## ORIGINATION FORM

Proposed Revisions to a Standard Plans Index  
(Please provide all information — Incomplete forms will be returned)

Index Number: 520-010  
Sheet Number (s): All  
Index Title: Median Opening Flume

# REDEVELOPED INDEX

## NEW SUB SECTION: MEDIAN OPENING DETAILS

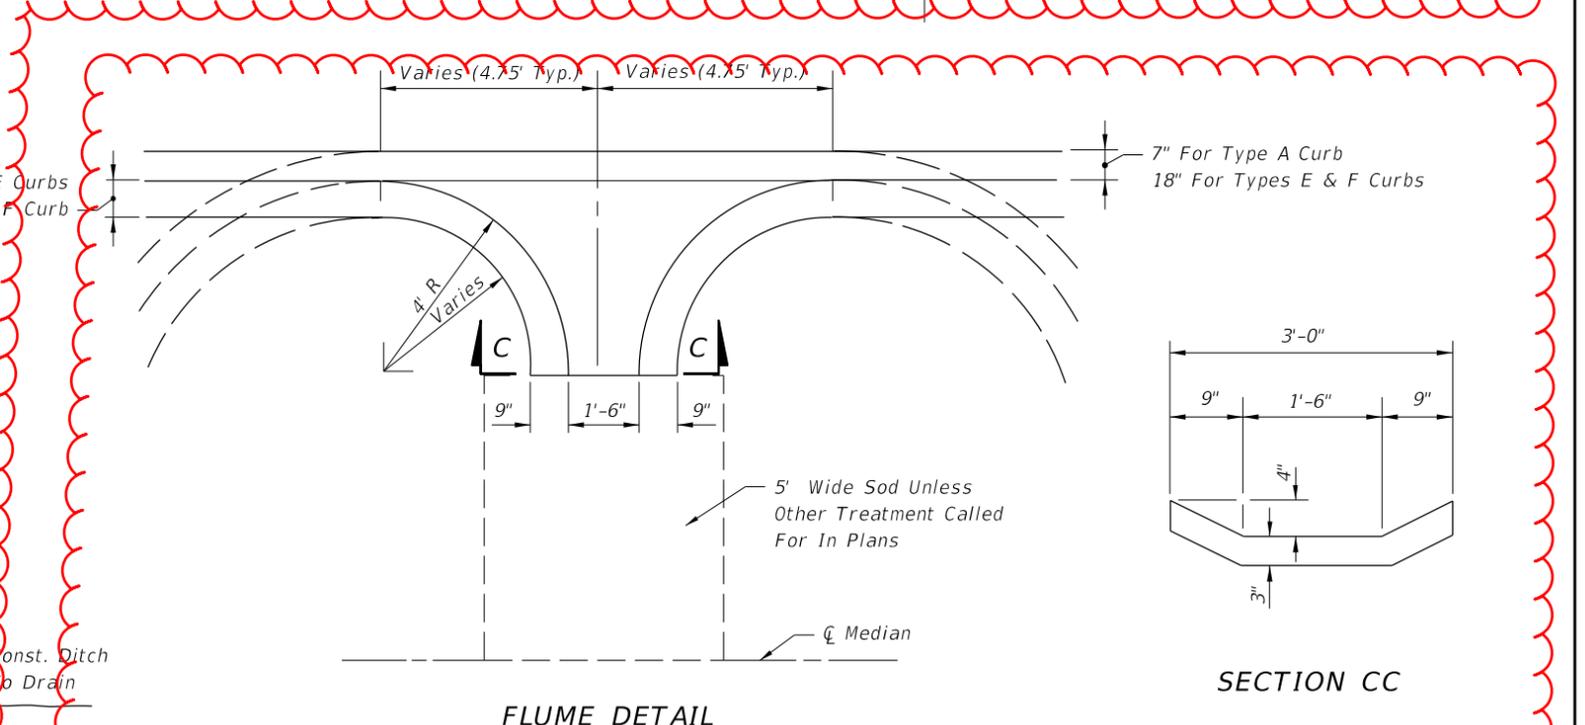
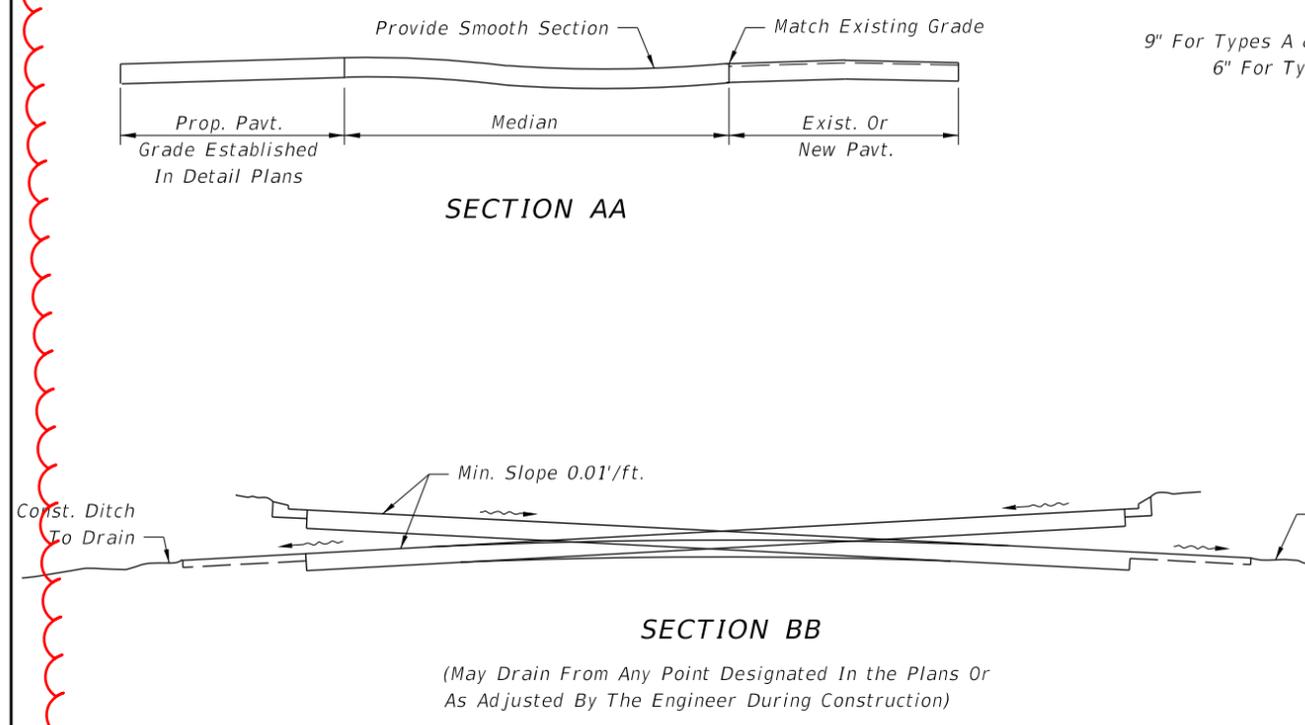
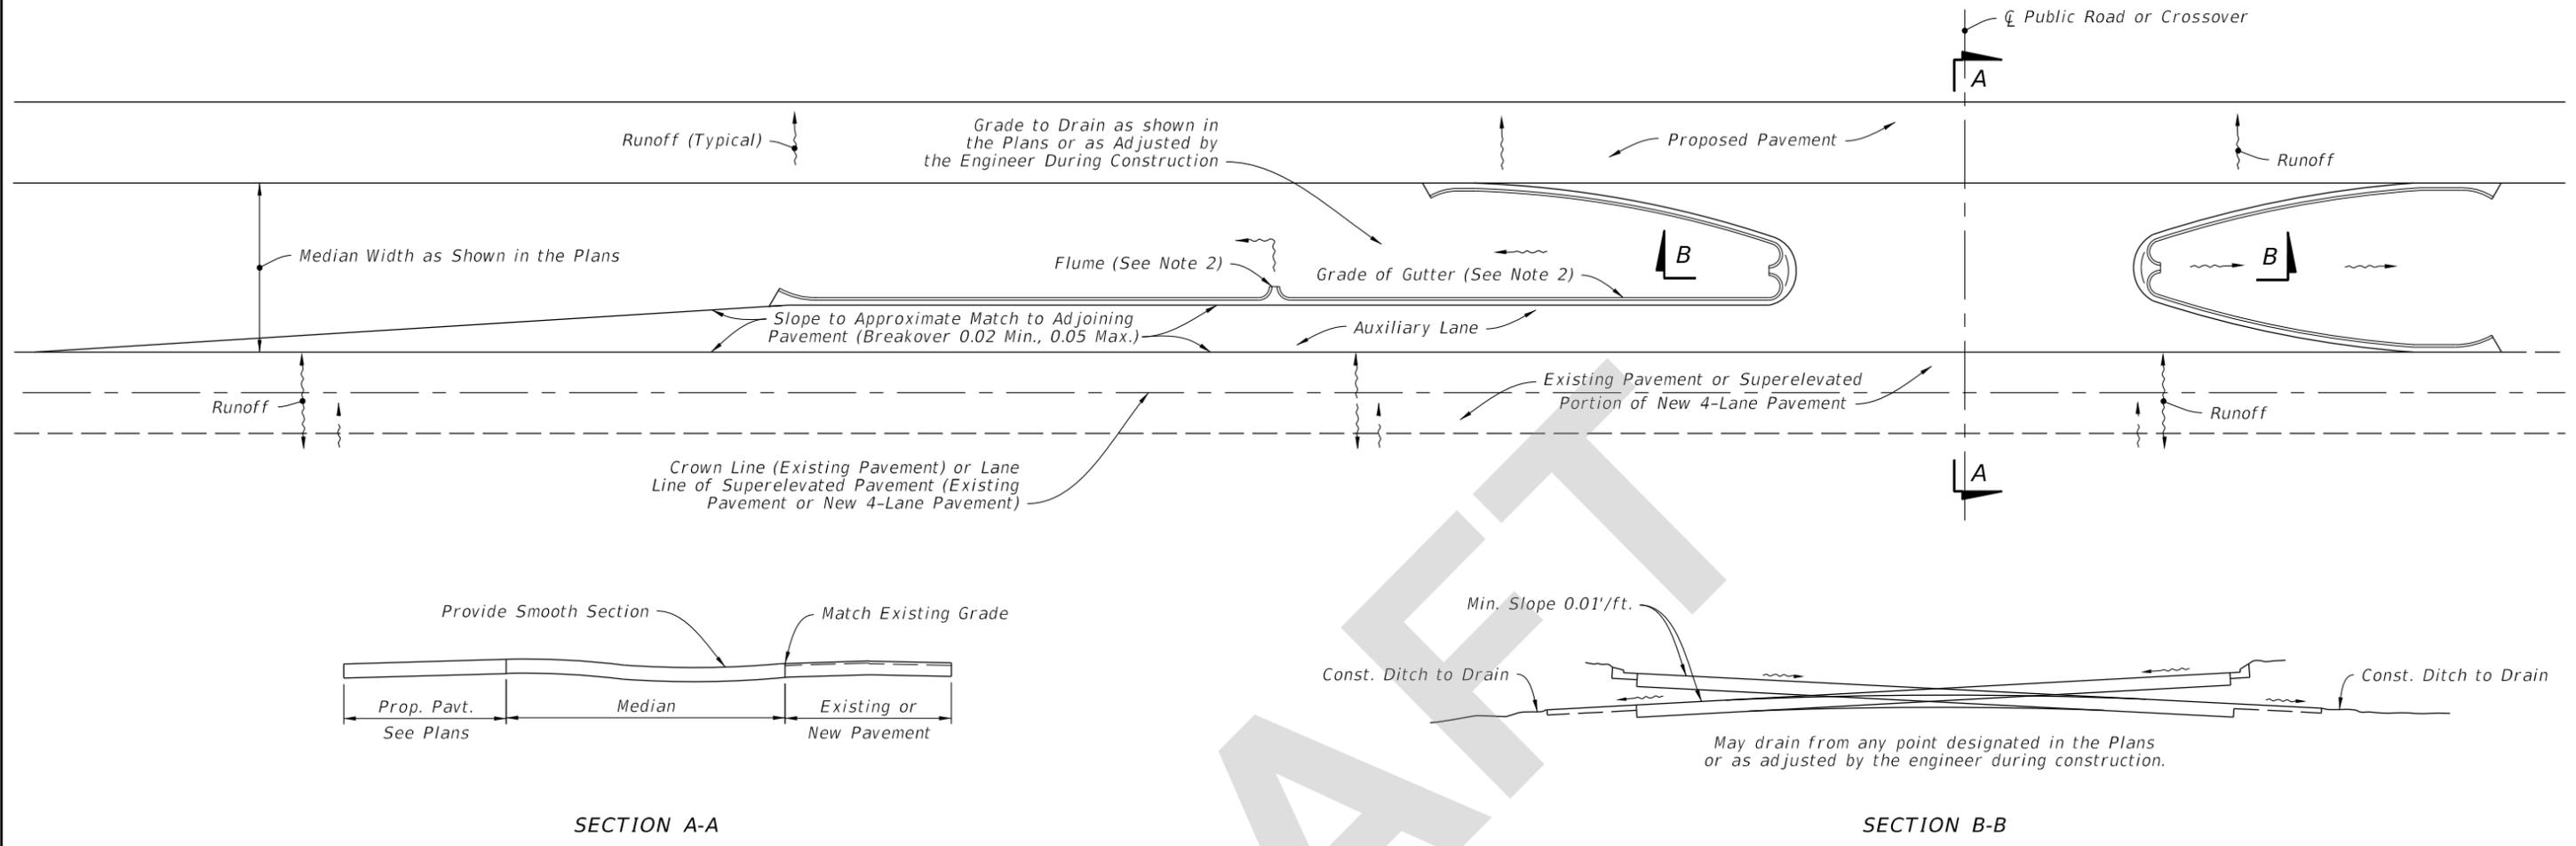
Created new Note 2

~~Provide Approximately A Minimum Of 0.20% Grade On Gutter, Slightly Warping The Surface Of The Median Pavement If Necessary, Within Limits Of The Median Curb Or Curb And Gutter. Construct A Drainage Flume Or Flumes At The Point Or Points Of Low Grade. See Details.~~

Update notes to remove payment info and delete design criteria that is located in SPI

1. These details are to apply to projects which provide for the conversion of 2-lane sections to 4-lane divided highway sections and for superelevated sections of new 4-lane divided highways. Layout above is illustration only. ~~Cost of flumes to be included in the contract price for Curb or Curb and Gutter. Sod to be paid for under the contract unit price for Performance Turf, SY.~~
2. ~~Flumes to be located in low point of noses and at other points as designated in the plans.~~ The locations may be adjusted by the Engineer during construction.

LAST REVISION 11/01/21	REVISION	DESCRIPTION:		FY 2022-23 STANDARD PLANS	MEDIAN OPENING FLUME	INDEX 520-010	SHEET 1 of 1
---------------------------	----------	--------------	--	------------------------------	----------------------	------------------	-----------------

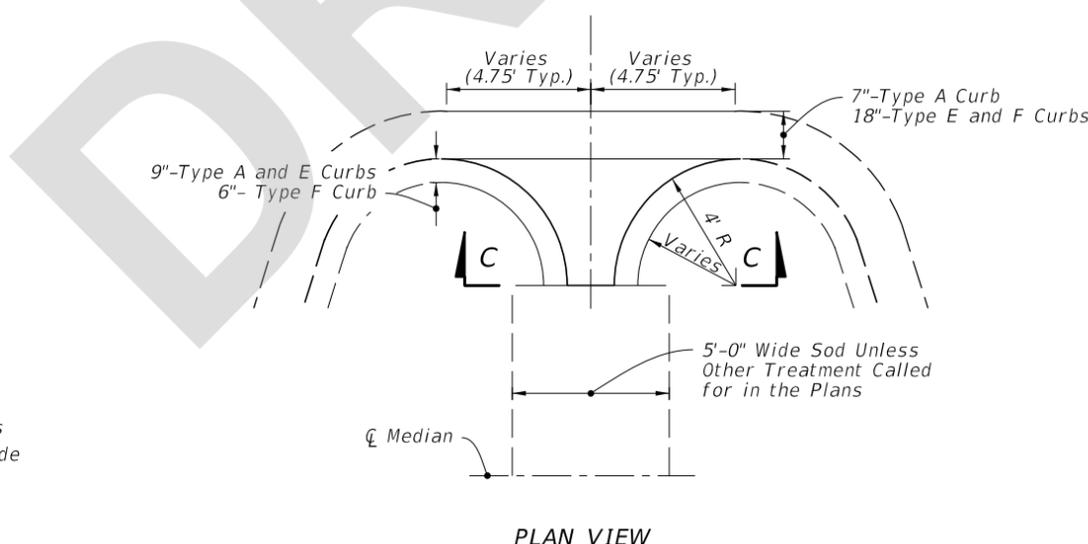
Redrew details; Rewrote notes

Revised and reorganized details to match other indexes. Rewrote notes and deleted pay item and design information that is now located in the SPI.

1. These details are to apply to projects which provide for the conversion of 2-lane sections to 4-lane divided highway sections and for superelevated sections of new 4-lane divided highways. Layout above is illustration only.
2. See Plans for flume length and location and grade of gutter. Flume locations may be adjusted by the Engineer during construction. If necessary to provide minimum gutter grade, warp surface of the median pavement within limits of the median curb or curb and gutter.
